Product Change Notification

PCN-IFC-7734-2022

Business Unit	Product Line Code	Type of Change	Action	Date of Issue
IFC - Industrial Field Connectivity	BF1	Product Change Notification	Notify Distributors and Field	3/4/2022

Description for Product Change Notification

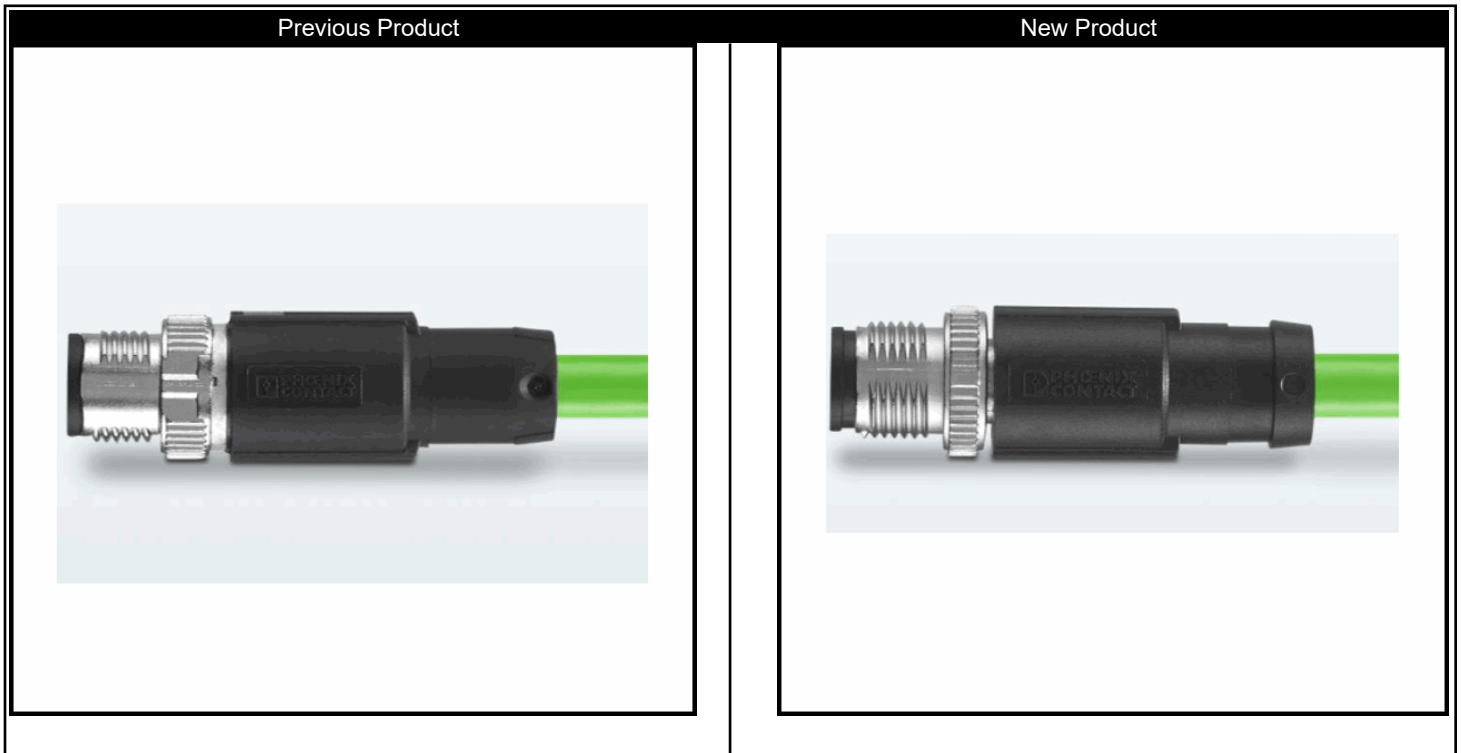
The D-code Ethernet product range manufactured in the USA will be upgraded to Advanced Shielding Technology (AST). As a result, the previously used crimp shielding sleeves will be replaced by the AST design. The overmold will be somewhat thinner and the product technically improved. Advanced Shielding Technology from Phoenix Contact is the innovative shielding concept for data, sensor and power cabling. The large-area, material-bonding 360° shield connection is unique on the market and optimizes the current design of M8 and M12 connectors.
